# Historic Preservation Commission

## Staff Report

**Case #:** HPC-13-26

**Proposed Work:** Petition for a Certificate of Appropriateness for the construction of a parking space on the property located at 1316 Riverside Drive in the Caplewood Historic District (Council District 4).  
**Current Zoning:** MRU-H

Survey of Property showing proposed driveway to utilize the existing curb opening for a single parking space.

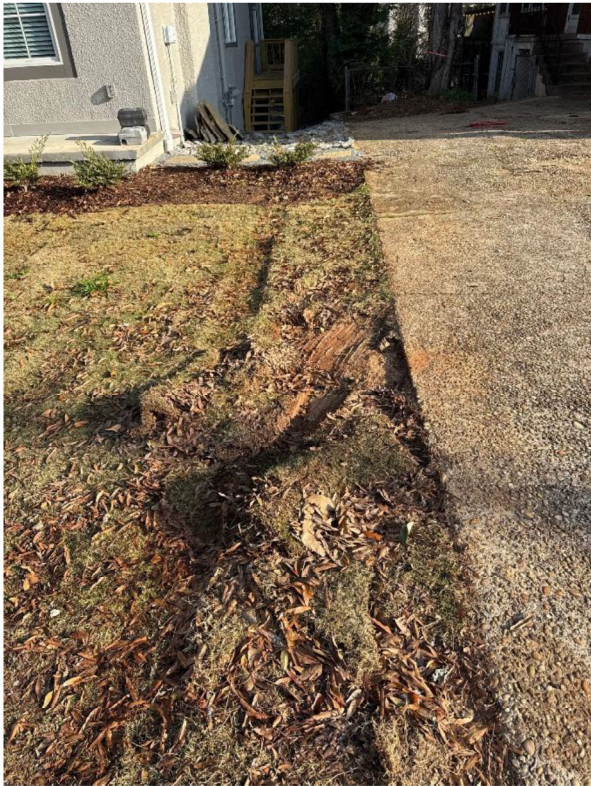
The petitioner proposes adding a new parking space in the front yard of the property. Using the existing curb opening, the proposed space would be located adjacent to the neighboring property's driveway to the east.

The new parking space would match the existing elevation and slope of the adjacent sidewalk and driveway. It is proposed to measure 16½ feet by 9½ feet and would be constructed of concrete consistent with the existing sidewalk and driveway materials.

Concrete is an appropriate material for parking per the Design Guidelines.
